Access Report

826 Victoria Road, Ryde
Proposed Childcare Centre

Development Application Design Phase

Date - 3 November 2022
For - The Trustees of the Roman Catholic Church for the Diocese of Saint Maron Sydney
Ref - 22280 – R1.1

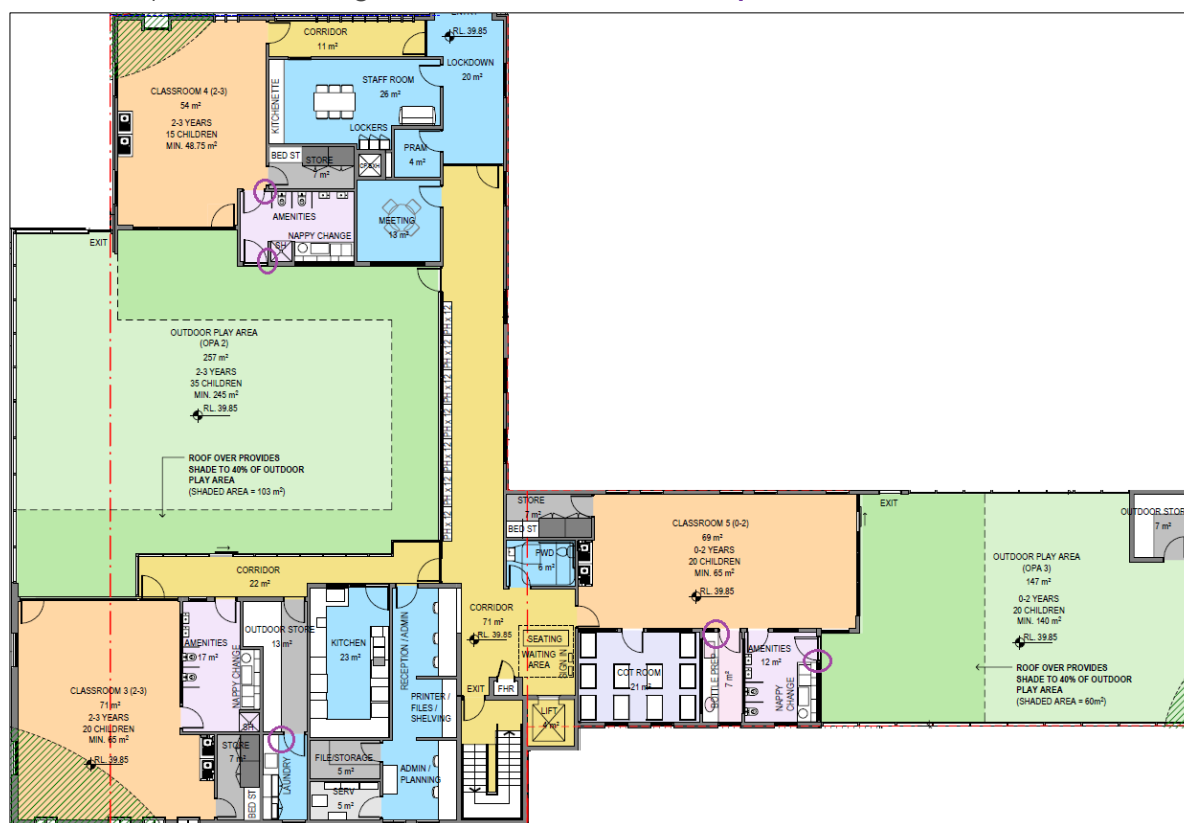
There are a number of doors throughout the building where cl. 13 of AS1428.1 circulation space is reduced at doorways and/or within rooms. This causes a compliance departure with BCA Clause D3.1.

See mark-up below showing identified doors outlined **Purple**:

A typical approach for these projects. The client will pursue a *BCA Performance Solution* at CC phase to demonstrate suitability of reduced doorway circulation to the subject doors.

Reliance will be place upon (amongst other things):

- Staff are required to be physically capable to carry out their employment obligations – statutory requirement;
- Managed use. Visitors to manages / present themselves at reception.
- Door hardware exempt from access requirements in a childcare centre.
